# Detailed Site Plan Departure from Design Standards Alternative Compliance McDonald's Ager Road

DSP-22001 DDS-23001 AC-23017

#### STAFF REPORT

McDonald's Ager Road

Figure 1: Parking Plan

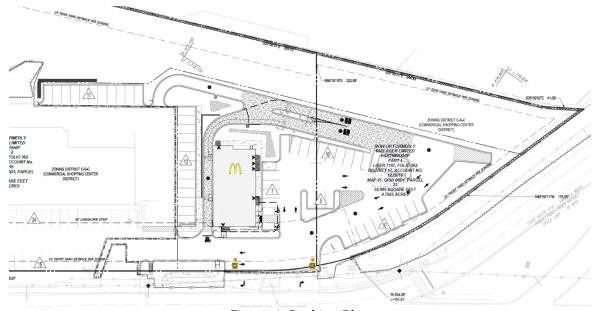
The proposed plan also includes adding 54 parking spaces to the existing parking lot, bringing the total number of parking spaces to 125. Specifically, 24 of the newly generated parking spaces will be located on the north side, while 30 will be situated south of the freestanding building.
